# Errata Sheet

<b>Product Family:</b>	DL205 / DL305	<b>Date:</b>	September 2018
<b>Manual Number</b>	D2-DCM		
<b>Revision and Date</b>	2nd Edition; February 2003

Page A-4. Point-to-Point RS422 D2–DCM as Master

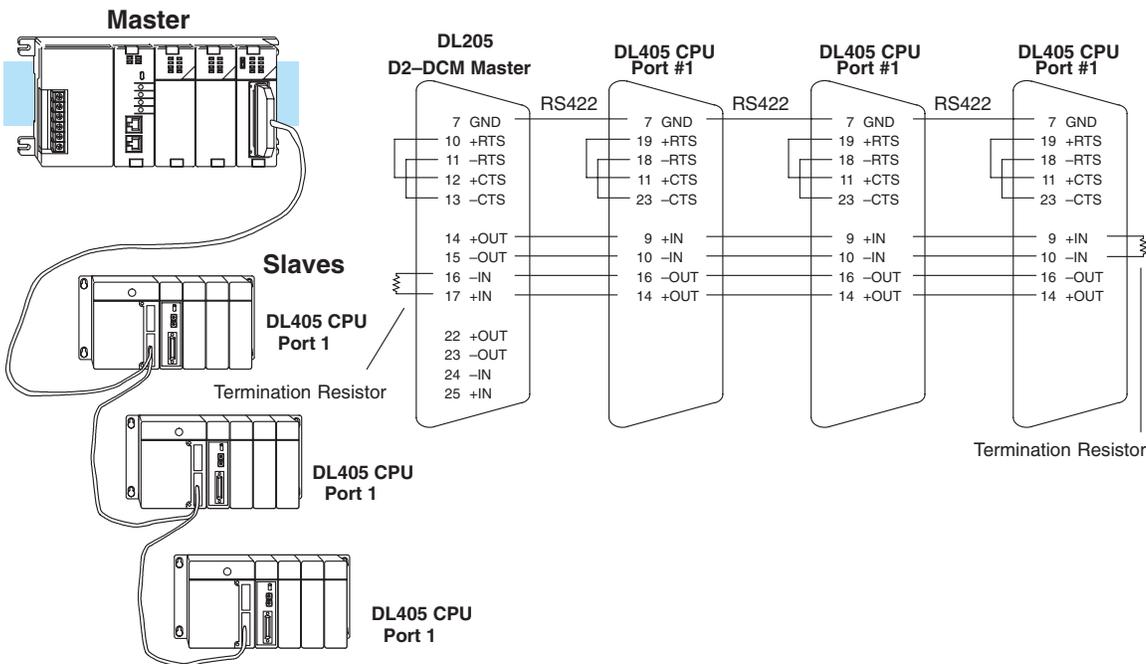
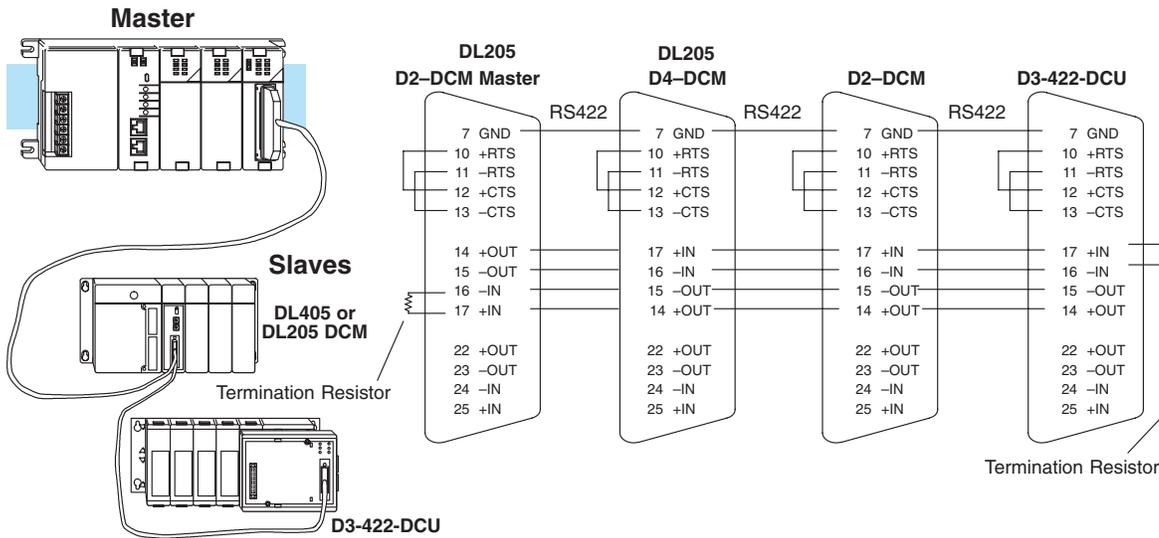
In the lower left drawing there are some pin number errors for the DL405 port 1 25-pin connector. The correct pin numbers are:

19 +RTS (not 10 as shown)

18 -RTS (not 11 as shown)

11 +CTS (not 12 as shown)

23 -CTS (not 13 as shown)

In the top set of drawings, change the callout that says “DL405 CPU Bottom Port” to DL405 Port 1”

**D2-DCM  
Switch Settings**

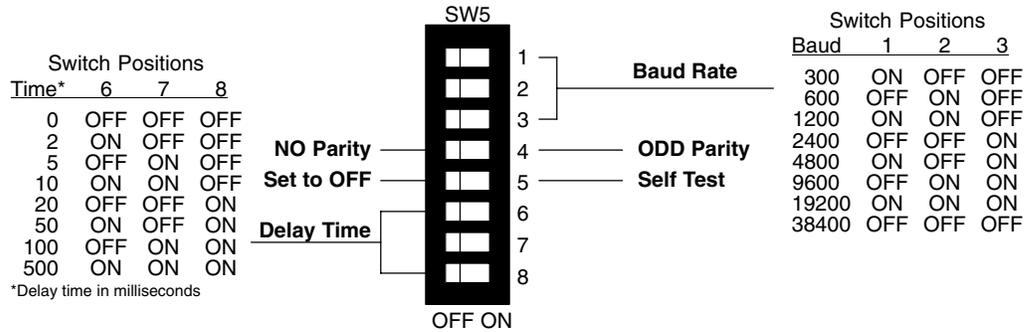
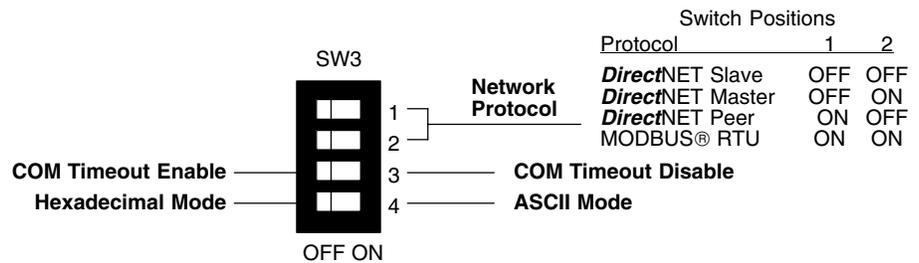
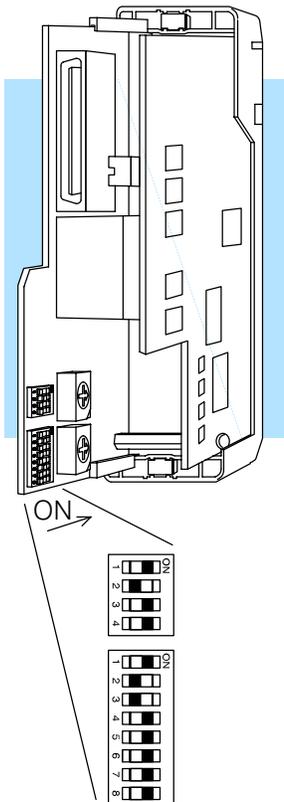
**NOTE: Although it is not listed in the switch settings, K-sequence is also available whenever the D2-DCM is set for DirectNET Slave operation.**
